Introduction of Compression Seal GTMS in HE3/HE5 Families

Description of Change: Glass To Metal Seal (GTMS) design change.

Part Numbers/Series/Families Affected: 10011-*

Visual comparison of parts before and after the change	
Standard GTMS (before the change)	GTMS with compression seal (after the change)

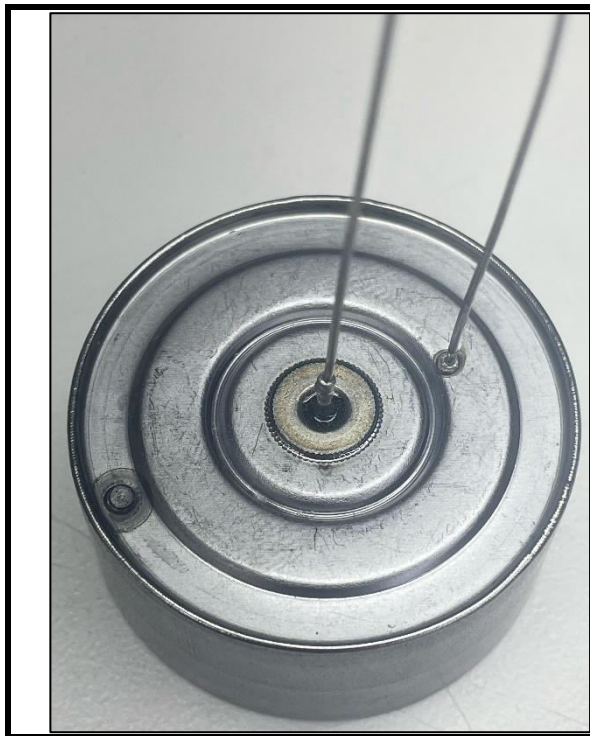
Reason for Change: To enhance product reliability and streamline manufacturing processes, Vishay is introducing a compression seal GTMS design for the HE3 and HE5 families, including DLA 10011 series. This change aligns with our commitment to continuous improvement and customer satisfaction.

Expected Influence on Quality/Reliability/Performance: Aside from an external appearance of the product, which will be slight, the performance of the product and its reliability will remain unaffected.
